## **Core Bus Corridor 9: Greenhills**

17th April 2020

**Fig.3 Making a Legible City – Key Spaces and Connections**

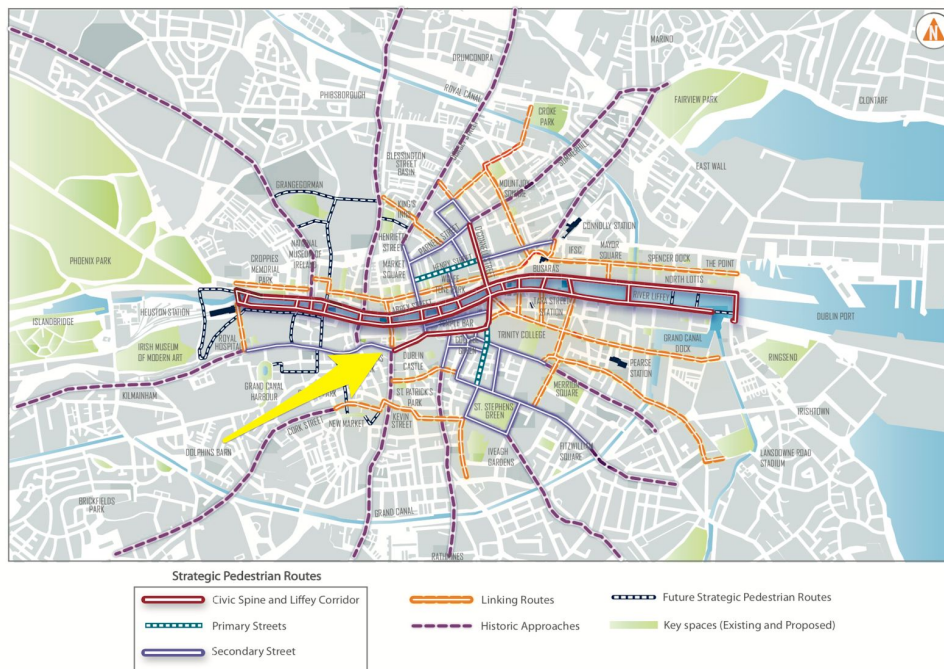
This junction is massively oversized, given that this is part of the core of Dublin. The Dublin City Development Plan identifies this junction as a key connection between a number of strategic pedestrian routes.

Consider more traffic management on the adjoining roads, such as turning restrictions or removing through-traffic, in order to reduce the size and complexity of this junction.
